Subject: Response to DMS comments on the Year 5 Monitoring Report Draft review for the Logan Creek Stream Restoration Project; Savannah River Basin - CU# 03060101; Jackson County, North Carolina; NCDMS Project # 92515; Contract No. D06046-A

Logan Creek Stream Restoration Project Year 5 Monitoring Report

**Jackson County, North Carolina
NCDMS Project ID Number – 92515**

**Profile of Logan Creek Thalweg, Station 32+43 to 42+81
Year to Year Comparison of Thalweg**

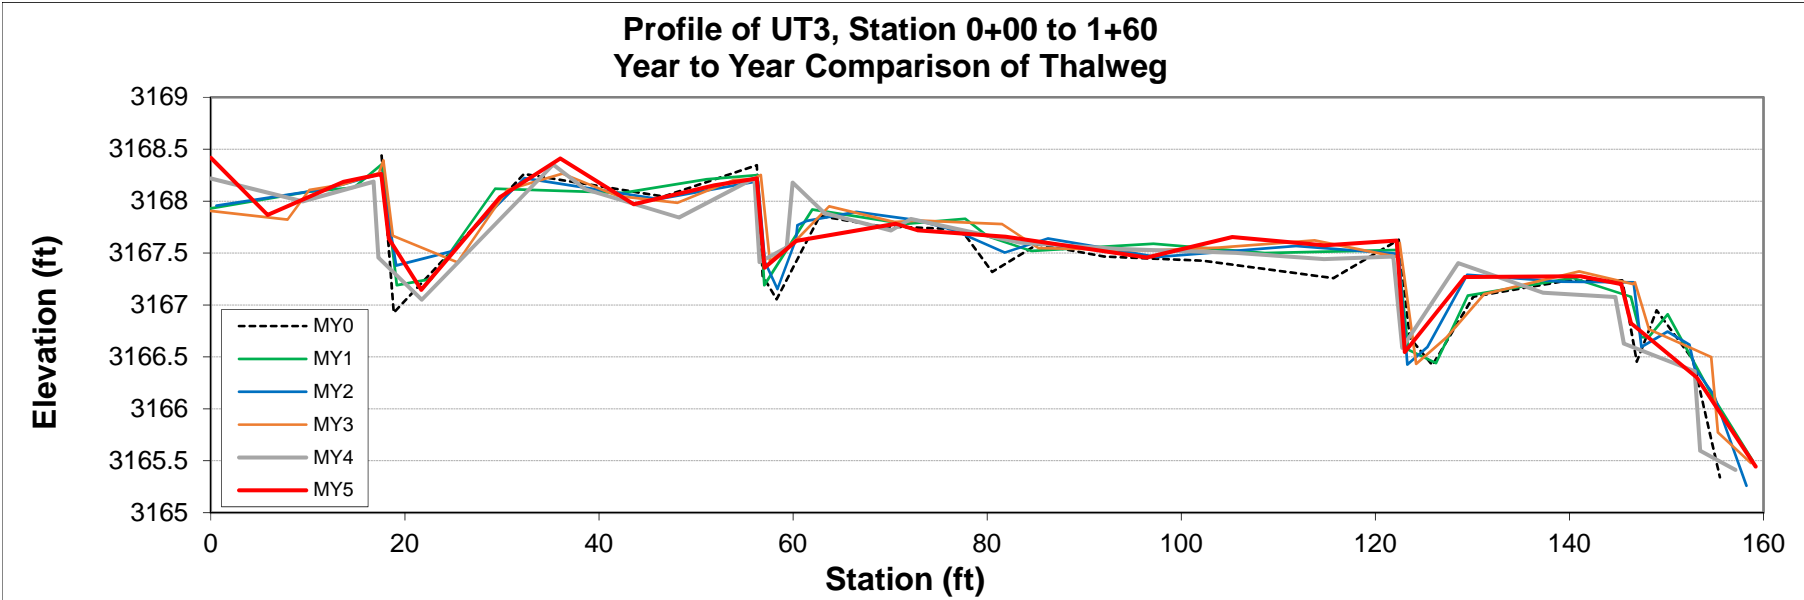
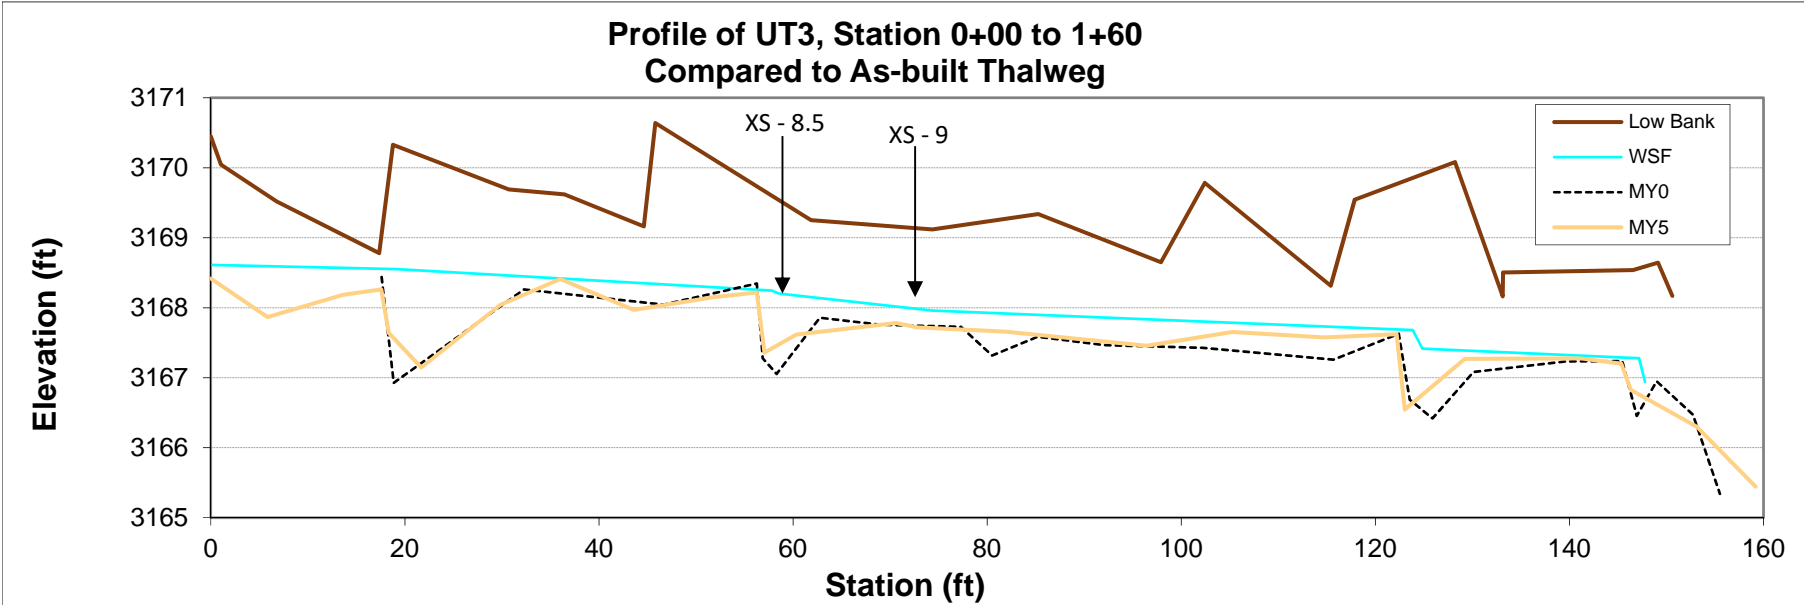
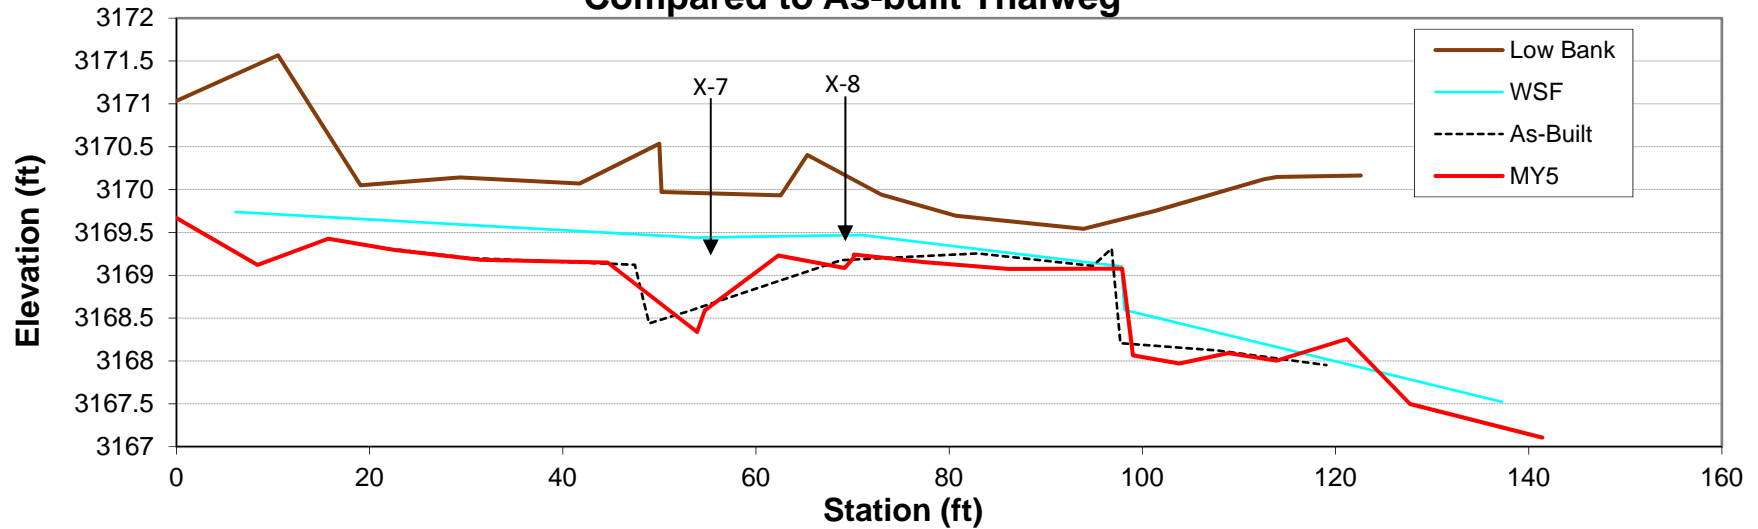
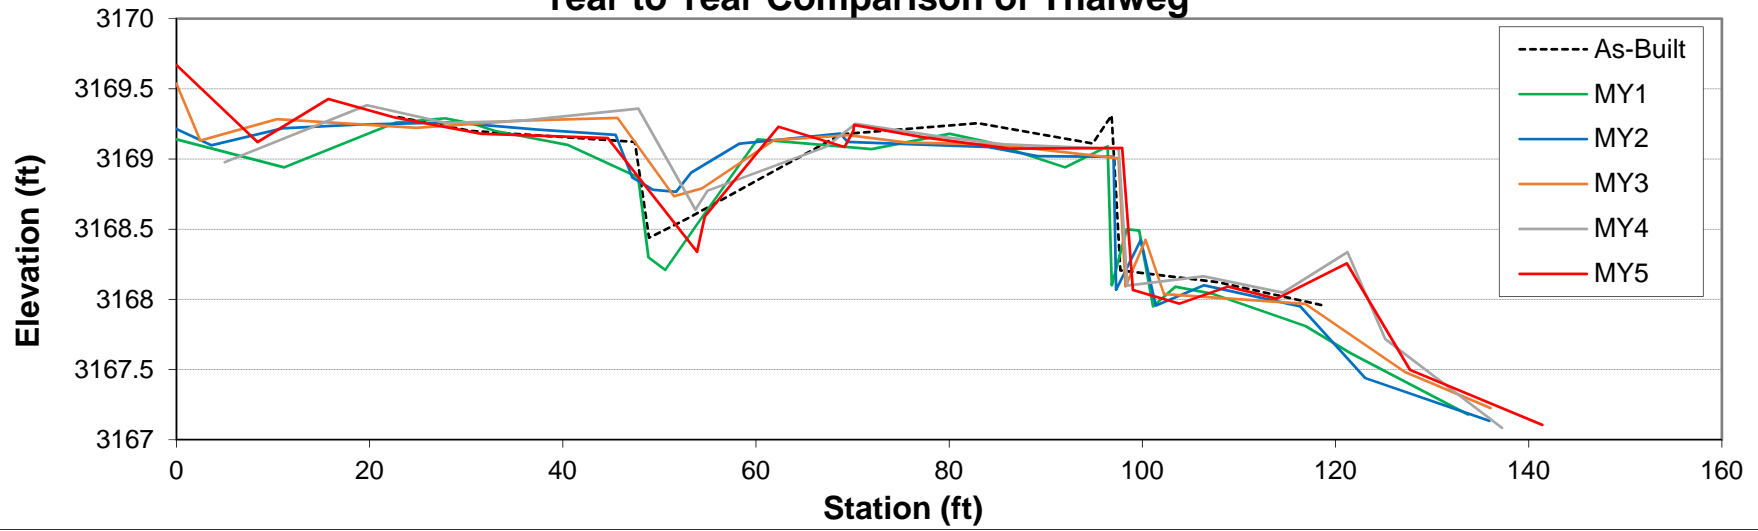
- **Table 9 – Verification of Bankfull or Greater than Bankfull Events:** DMS recommends adding a row for MY1 noting that no bankfull events were recorded in MY1.
A row for MY1 was added indicating do data was collected that year.
- **Profile of UT8:** The longitudinal profile just shows profile data from MY1 and MY5. A footnote is missing from the graph. Please be consistent with the other graphs. DMS recommends including the profile that shows MY1 compared to MY5 and a separate graph showing all longitudinal profile data collected for the reach over the monitoring term.
The UT8 profile was corrected so that both the MY1 to MY5 comparison and the profile showing the year to year comparison, are included. The footnote is also shown.

**Profile of UT8, Station 0+00 to 0+45
Compared to MY1 Thalweg***

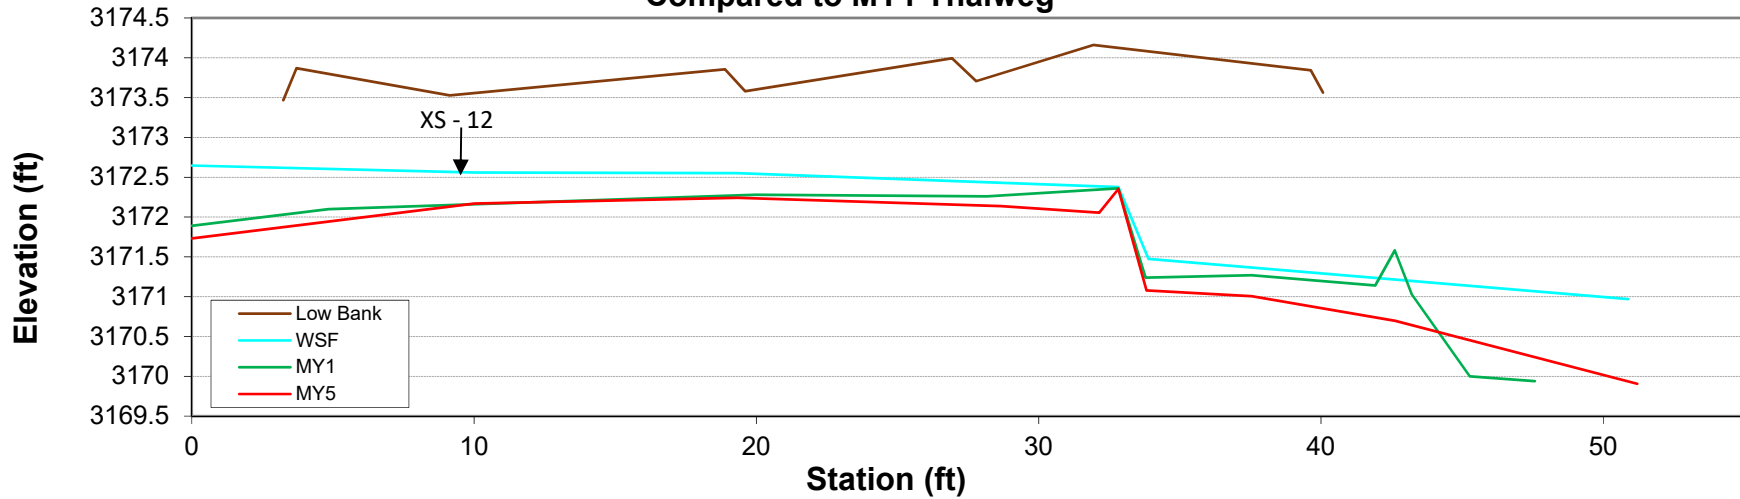
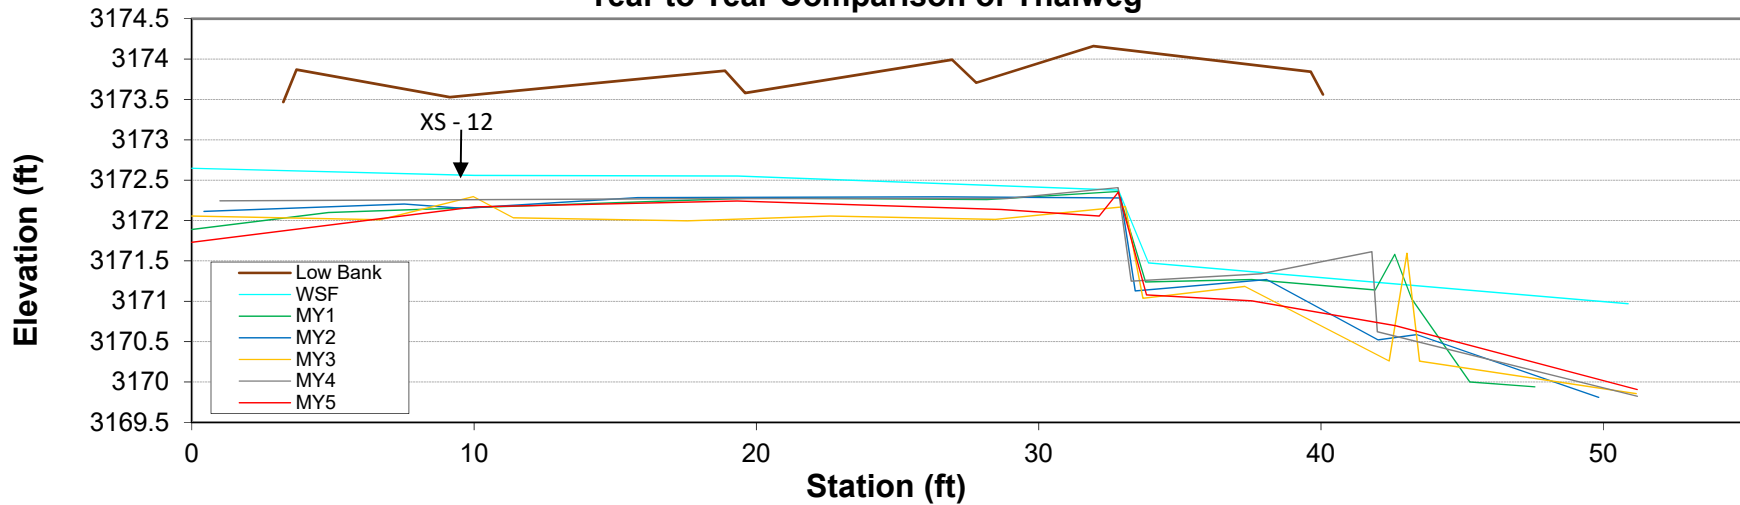
- **Executive Summary & Section 2.2.1-Morphologic parameters and Channel Stability:** In the report text, please briefly explain why the longitudinal profile for UT8 was not established in MY0. Please note when it was established and the monitoring years that data was collected for the reach. This text should be incorporated with the text noting the additional cross section on the reach.
The requested discussion of UT8 was added in the Executive Summary, but it was placed in the paragraph where the IRT site visit is discussed and reference was made to this UT. If this is unacceptable, we can modify where this is located.
